## **APPENDIX J**

USACE and SAFCA Responses to Comments on  
Previous NLIP Environmental Documents

J1 Phase 2 FEIR Master Response:  
Hydraulic Impacts on the NLIP

J2 Phase 3 FEIR Master Response:  
Sacramento River East Levee Prism and  
Master Response: 24/7 Cutoff Wall Construction

**Plate 4**

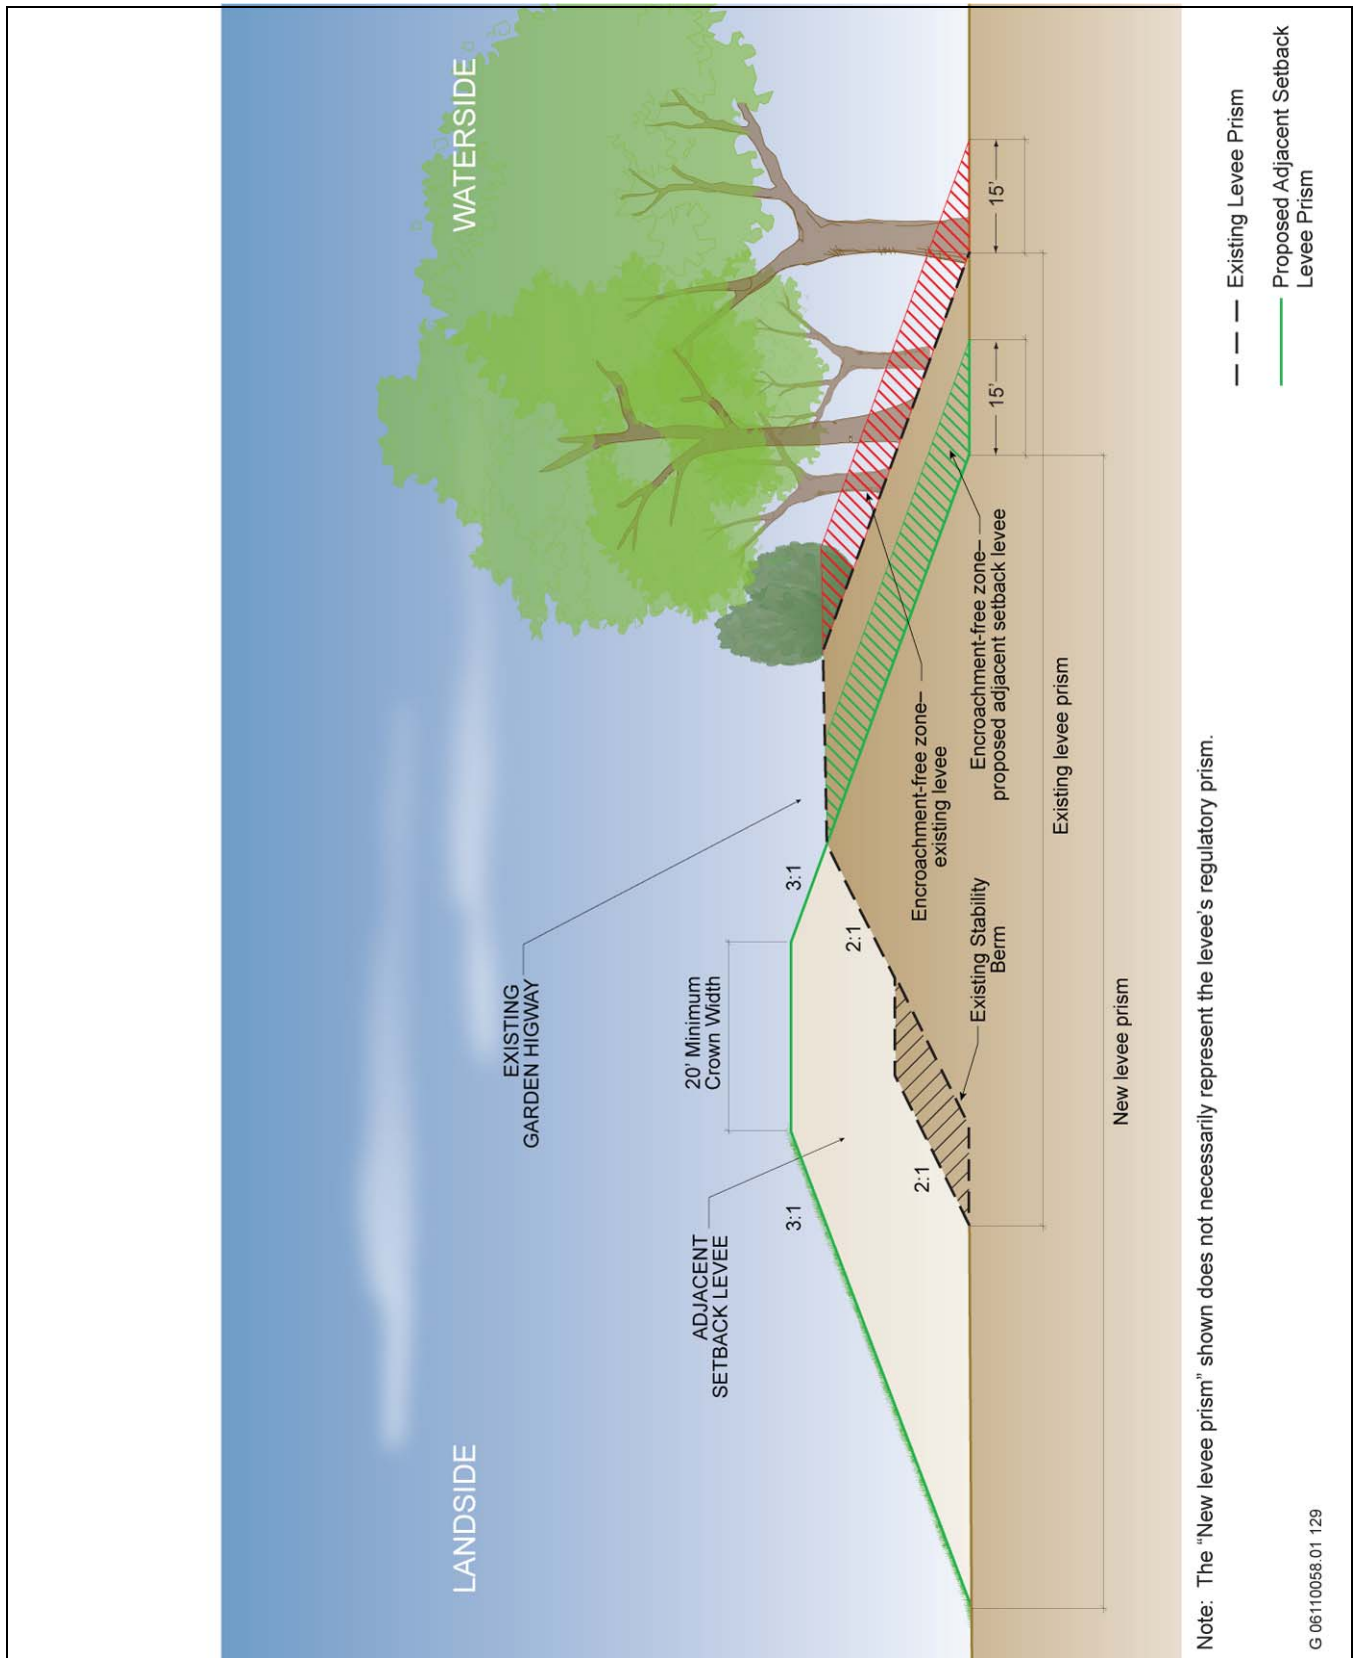
Several comment letters stated that the Phase 3 DEIS/DEIR did not provide enough information to fully explain the levee prism concept, the adjacent setback levee footprint, and potential construction-related impacts to vegetation and improvements. SAFCA has prepared the following response regarding the levee prism.

**Plate 4** shows a typical profile view of the existing levee along the east side of the Sacramento River in comparison to the adjacent setback levee proposed for the Phase 3 Project (Reaches 5A–9B). The prism for the existing levee consists of:

- ▶ the levee crown (a minimum of 20 feet wide), on which the Garden Highway currently sits;
- ▶ a landside levee slope, typically 2H:1V
- ▶ a landside stability berm; and
- ▶ a waterside slope that is defined by a projected 3H:1V slope from the waterside hinge point of the levee crown that may or may not be exposed depending upon natural ground surfaces and property improvements, such as construction fill for foundations and driveways.

The prism of the proposed adjacent setback levee would consist of:

- ▶ a minimum 20-foot crown,
- ▶ a 3H:1V landside slope from the hinge point of the levee crown,
- ▶ an exposed upper waterside slope from the hinge point of the adjacent levee crown to the landside of Garden Highway, and
- ▶ the continuation of a projected (non-exposed) minimum 3H:1V waterside slope through the existing levee to a point that would be set back a minimum of 15 feet from the existing waterside toe.

The setting back of the Sacramento River east levee under the Proposed Action would provide the USACE-required 15 feet of clearance of encroachments (including vegetation greater than 2 inches in diameter) from the theoretical waterside toe of the new adjacent setback levee. As shown on **Plate 4**, this approach would shift the encroachment-free zone landward, potentially reducing the extent to which USACE, the State, SAFCA, and RD 1000 would require the removal of existing encroachments to meet this requirement under the Levee Raise-in-Place Alternative. The impact of the removal of waterside vegetation greater than 2 inches that would potentially occur in the event of that the adjacent setback levee would not be constructed was analyzed in the Phase 3 DEIS/DEIR under Impact 4.8-a, “Loss of Woodland Habitats,” under the Levee Raise-in-Place Alternative. This loss was estimated to be up to 22 acres for Reaches 5A–9B.
